30S-1 RF LINEAR AMPLIFIER

SERVICE BULLETIN NO 3

REDUCE EXCESSIVE ALC CONTROL

30S-1 SB 3 Modification, Components -- Wiring Locations
Figure 1

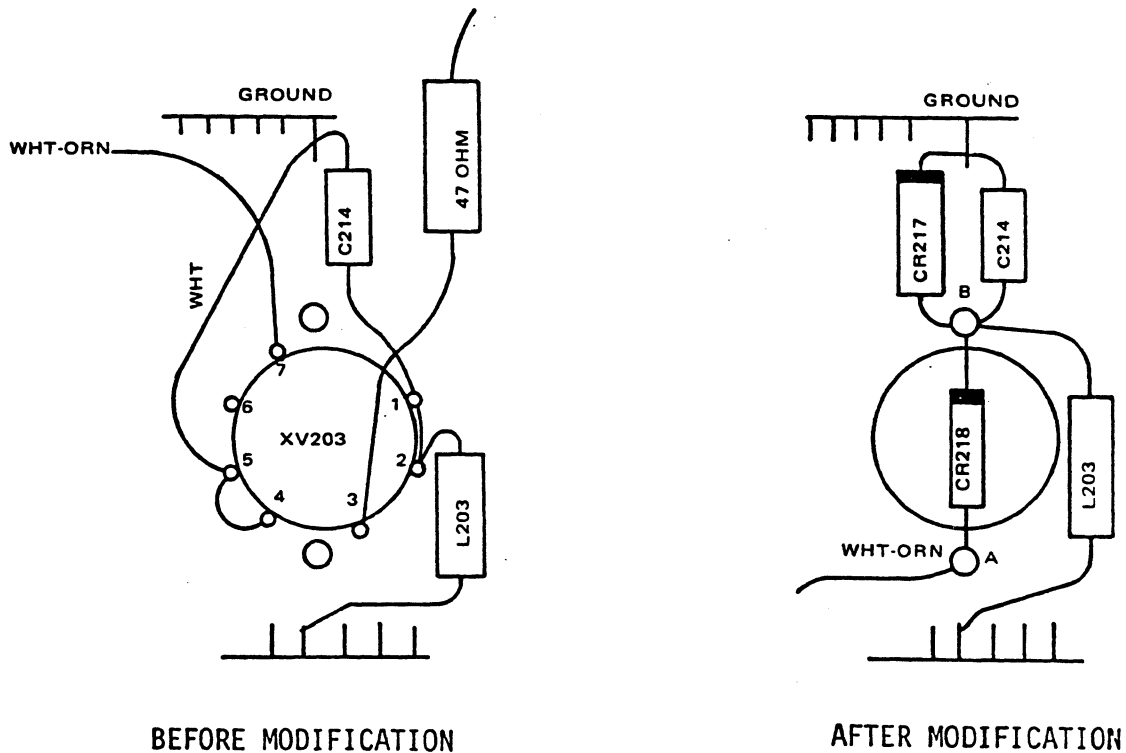
NOTE: Refer to figure 1 for component and wiring locations in following steps.

3. Remove and discard white wire from XV203 pins 4 and 5 to terminal strip ground.
4. Remove securing hardware and lift socket XV203 out of the way.
5. Install two terminals A and B (306-0234-000) in removed XV203 socket mounting holes with screws (343-0285-000) and washers (373-8010-000).
6. Disconnect white-orange wire (from J202) at XV203-7 and reconnect it to terminal A.
7. Disconnect L203 lead from XV203-2 and reconnect to terminal B.
8. Disconnect C214 lead from XV203-1 and reconnect to terminal B. Discard XV203 that is now free of circuit.
9. Install 1N457 diode CR218 (353-0204-000) from terminal A to terminal B (banded end).
10. Install 1N457 diode CR217 (353-0204-000) from terminal B to terminal strip ground (banded end).

30S-1 SB 3 Modification, Schematic Diagram, Partial View
Figure 2

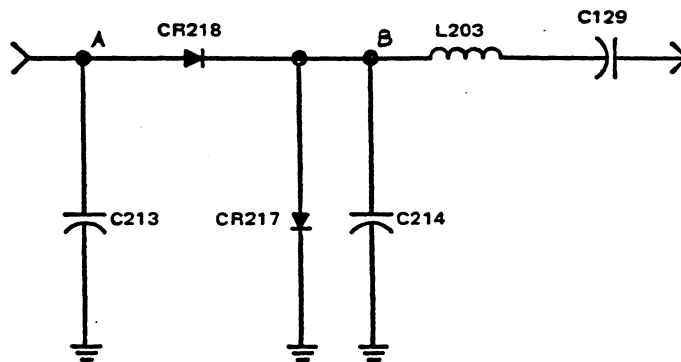
NOTE: Figure 2 is a schematic presentation of the modification.
